STATE OF NEW HAMPSHIRE INTER-DEPARTMENT COMMUNICATION

SUBJECT: Response to Request for More Information
Woodstock, 42534
NHDES File Number: 2023-02365

Project name:
Woodstock Route 175 Bridge Pier
42534

Subject: NH DES RFMI File Number 2023-02365

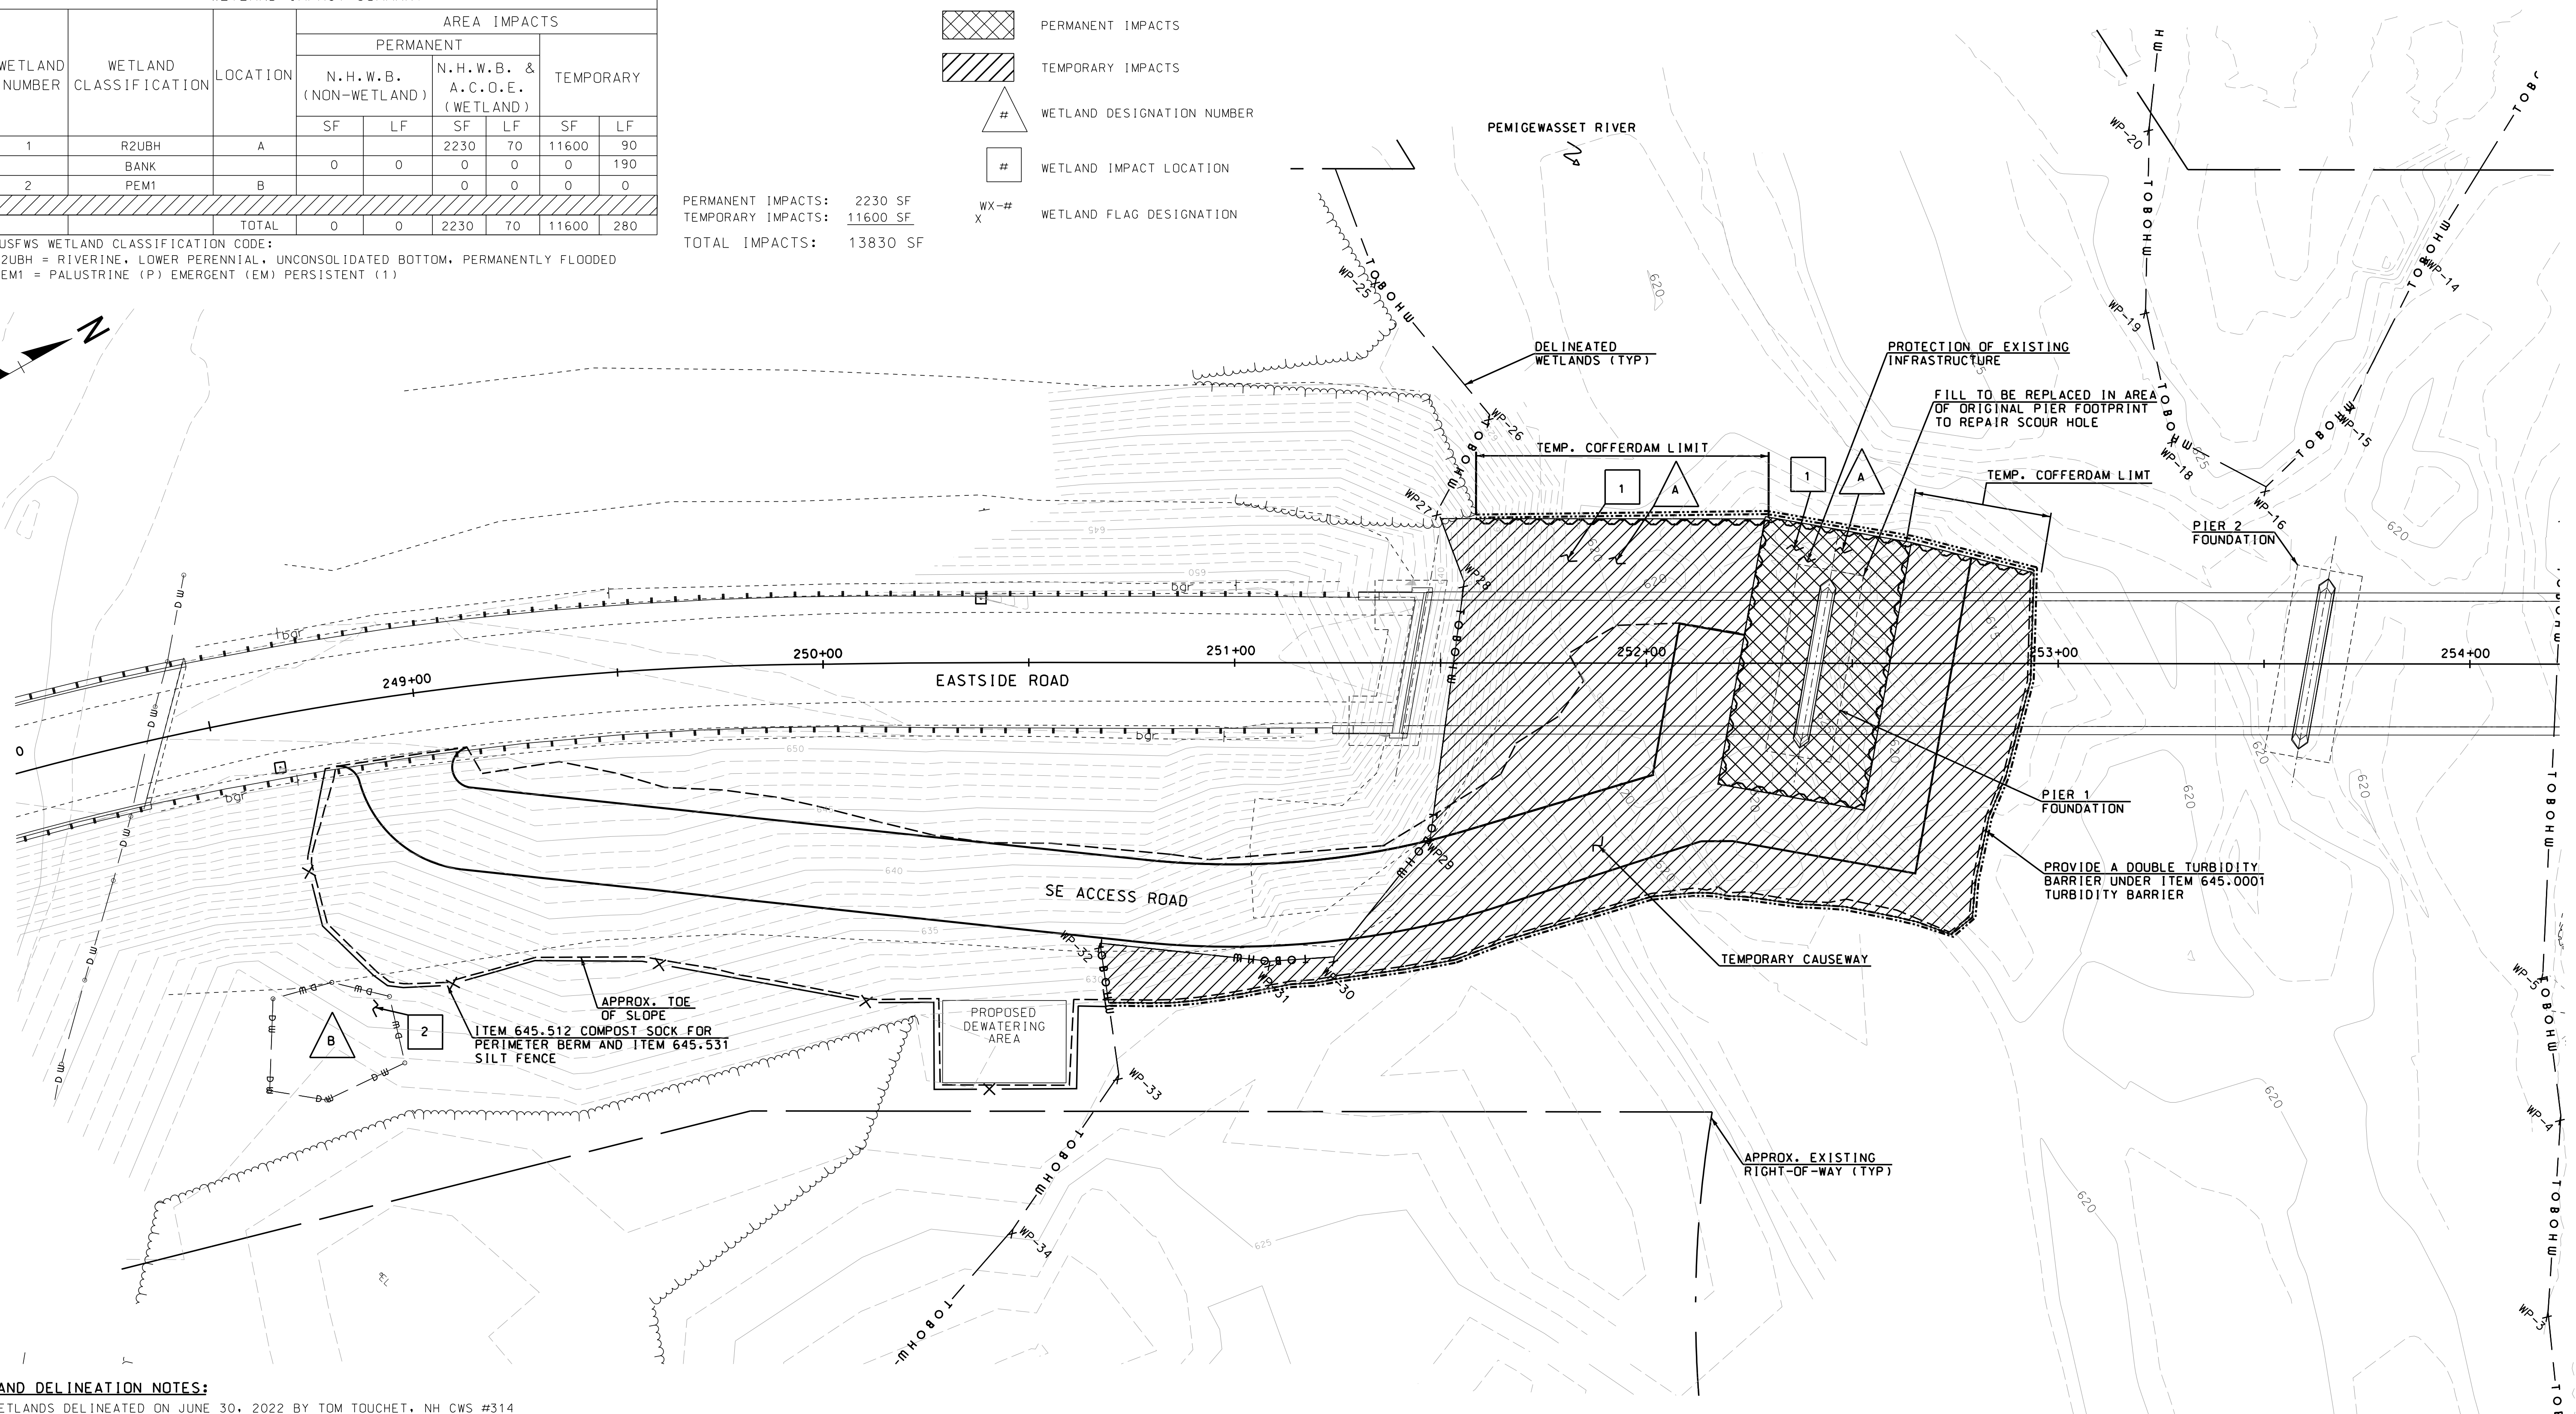
- 1- The wetland permit application requested 11,600 square feet of temporary impacts. There are an additional 2,275 square foot area on the bed of the river that will be permanently impacted by the construction of the cofferdam, fill, and concrete cap which were not accounted for. Please revise the plan impact areas to accurately represent the proposed project impacts and submit the associated wetland impact fee.

1. *Revise the plan impact area to represent the replacement of rip-rap fill around Pier 1 as a permanent impact.* The Wetland Impact Plan sheet for the project has been revised to illustrate the replacement of rip-rap fill around Pier 1 as permanent impact and is enclosed for your review.

Response: An updated Wetlands Impact Plan is attached with updated impact numbers. The updated plan indicates an additional 2,230 ft² of impacts associated with the project, which was calculated using CAD for the area of the cofferdam (minus the existing pier itself), however a voucher was requested for the greater amount 2,275 ft² of impacts to fully satisfy this RFMI item. The voucher (#740010) was requested for the remaining impacts in the amount of \$910.00 (2,275 x 0.40).
